**Economic and Social Council**Distr.: General
Date: 1 July 2021

World Forum for Harmonization of Vehicle Regulations**Working Party on Noise and Tyres****Seventy-fourth session**

Tyres: UN Regulation No. 108 (Retreaded tyres for passenger cars and their trailers)**Proposal for amendments to UN Regulation No. 108****Submitted by the experts from the Bureau International Permanent des Associations de Vendeurs et Rechapeurs de Pneumatiques (BIPAVÉR), France and the Netherlands***

Annex 3,

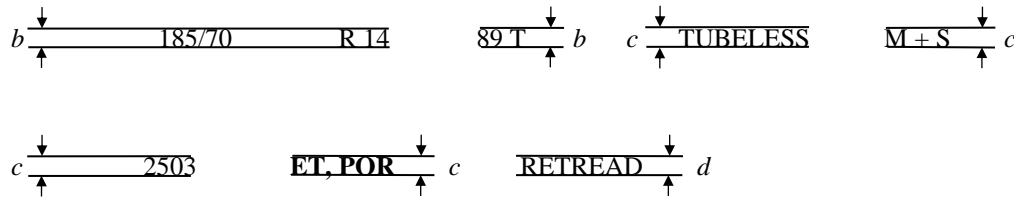
Paragraph 1., amend to read:

- “1. Example of the markings to be borne by retreaded tyres placed on the market after the entry into force of this Regulation

of special-use professional off-road (POR) or extra tread (ET) type. “
